PLAT of the

Proposed change of the Intake of what is known as the
Swinden Irrigating Ditch
which takes water out of the Applegate River in NW $\frac{1}{4}$ of NW $\frac{1}{4}$ Sec 27,
Town 37 S. R. 5. West Josephine. County Or.
Said Intake to be move further up Stream to a point in Sec. 35
same Township on South bank of River.

State of Oregon }
County of Josephine } ss
Application No. 586-537-35
Enlargement Permit No. 42-40-35
I hereby Certify that this Map was taken from the field notes
during an actual survey made by me on the 6th day of September 1909
and it correctly represent the proposed Intake in Sec 35 T 37 S R 5 W. and
the route of the ditch to be build to its junction with the present Ditch
Also the route of the present Swinden Irrigation Ditch to its Terminus
William P Wright
Surveyor.

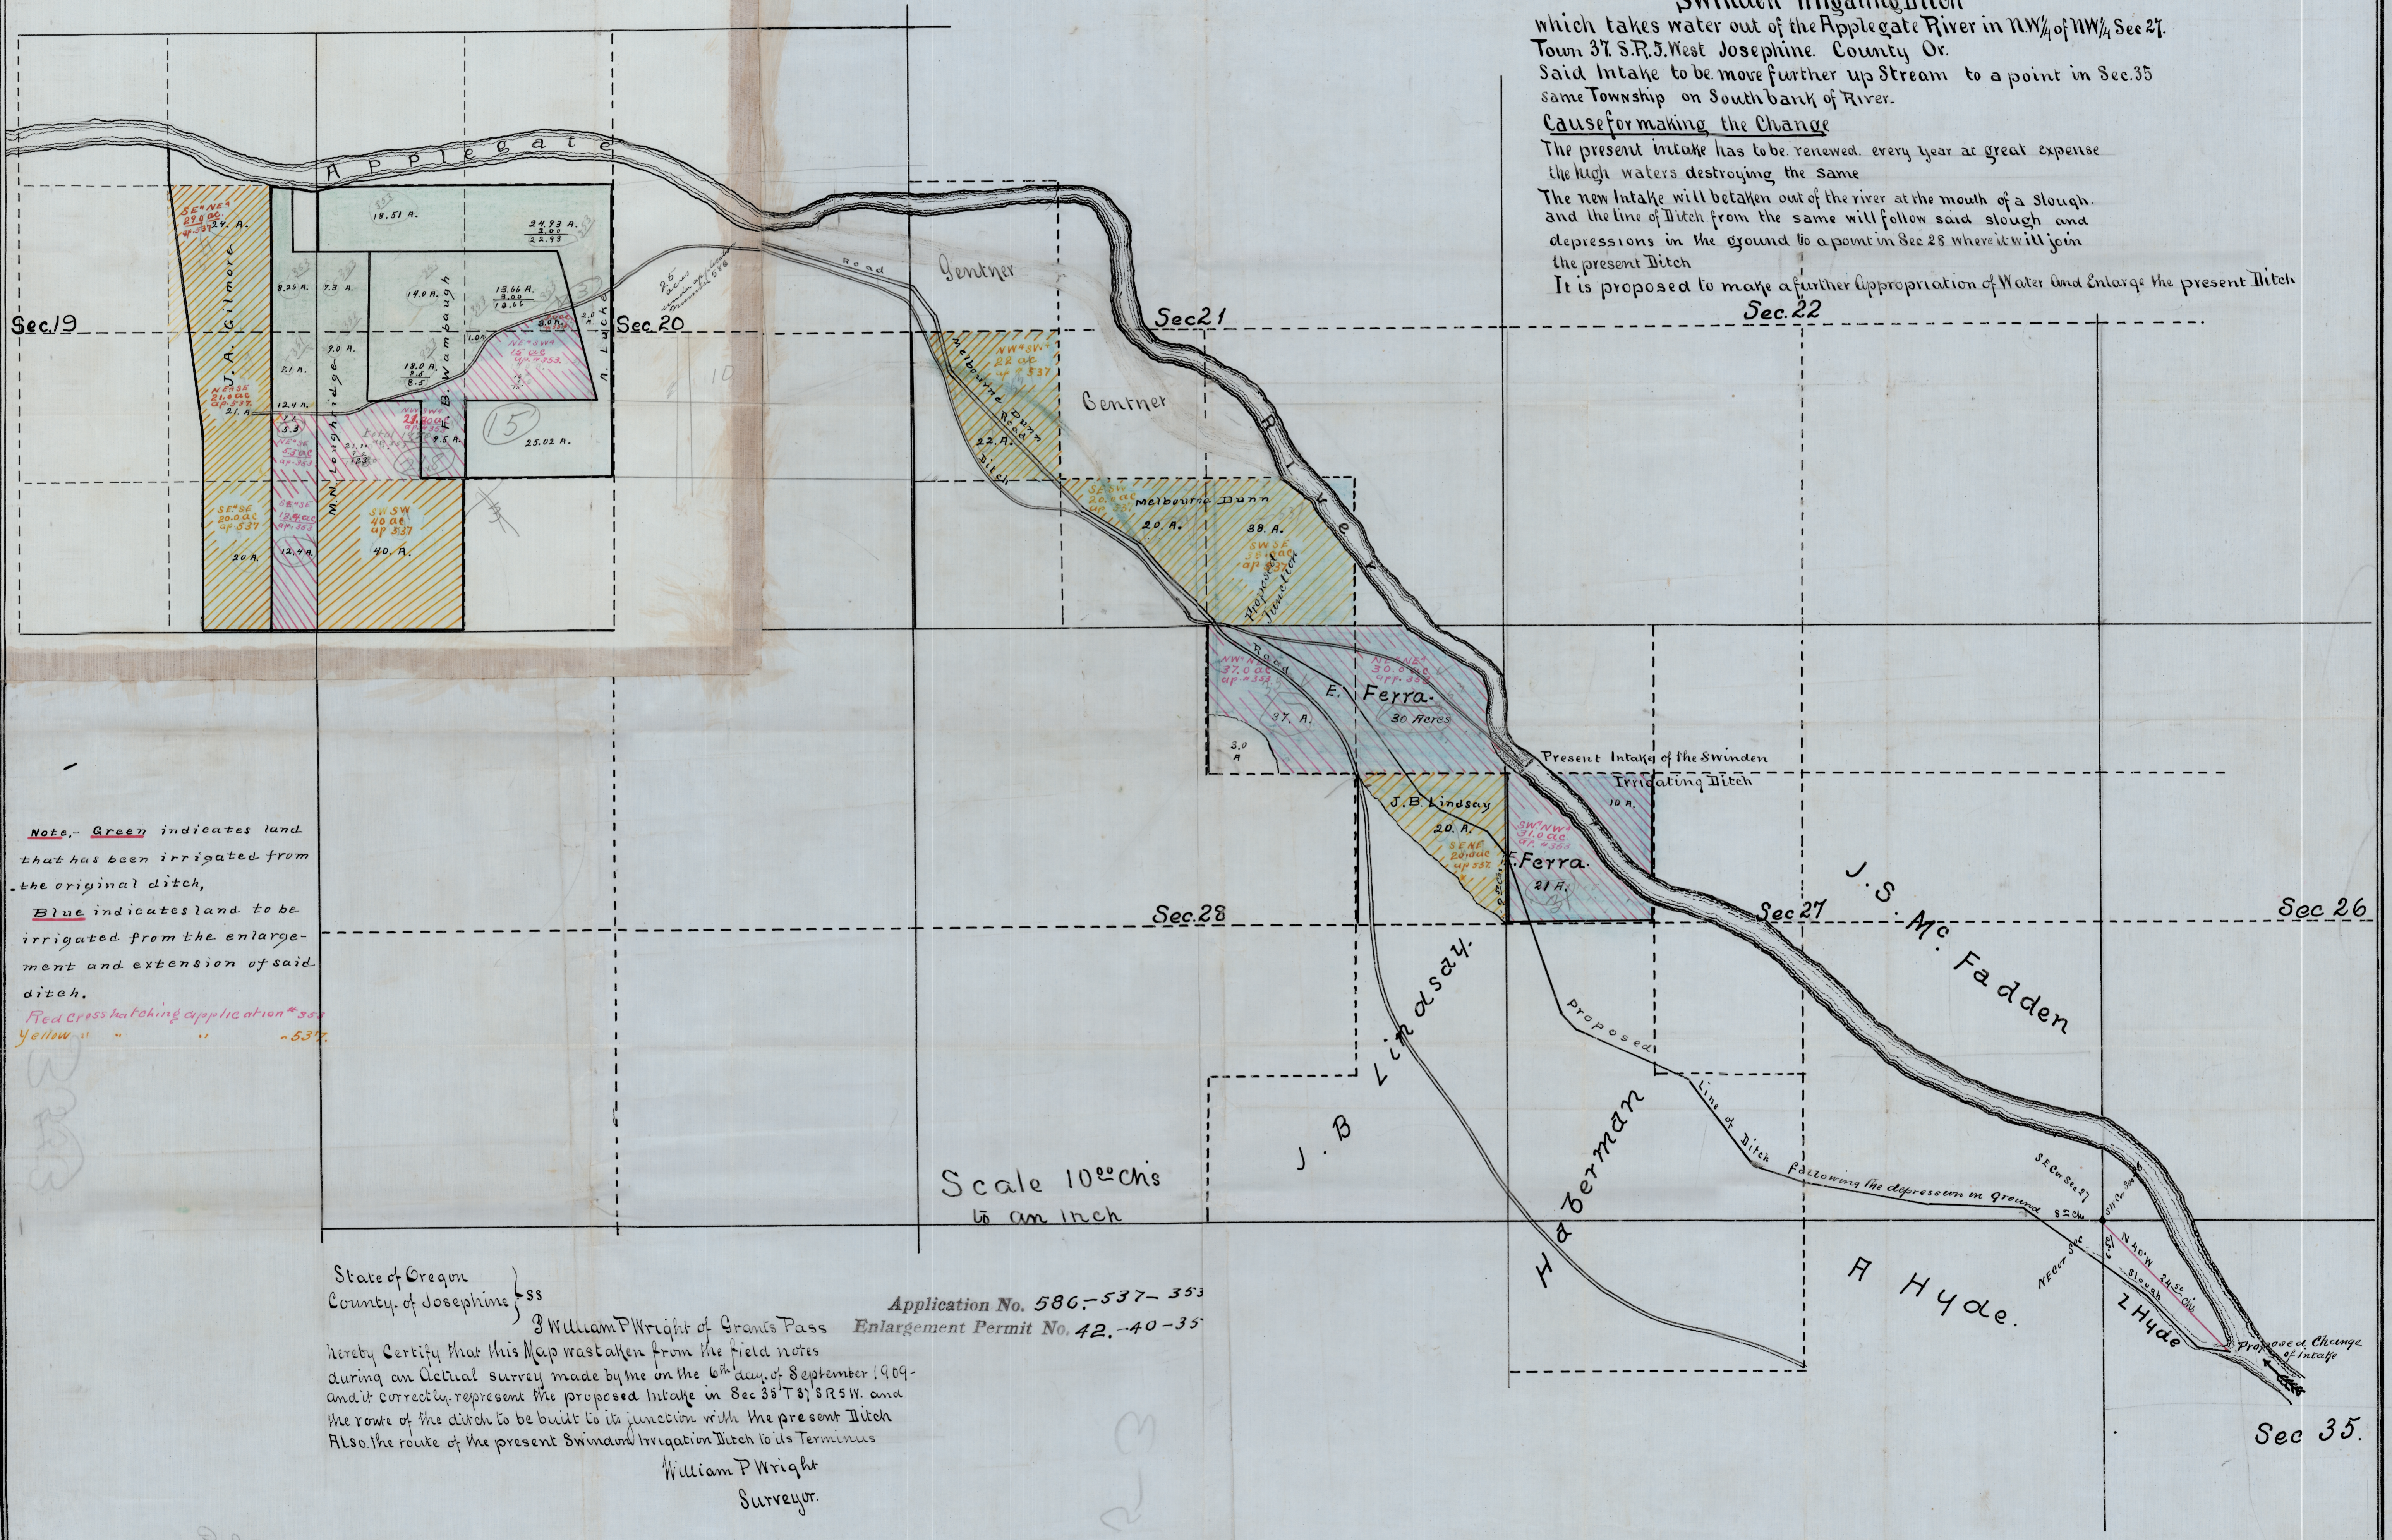
Cause for making the Change

The present intake has to be renewed, every year at great expense
the high waters destroying the same

The new Intake will be taken out of the river at the mouth of a Slough
and the line of Ditch from the same will follow said slough and
depressions in the ground to a point in Sec 28 where it will join
the present Ditch

It is proposed to make a further Appropriation of Water and Enlarge the present Ditch
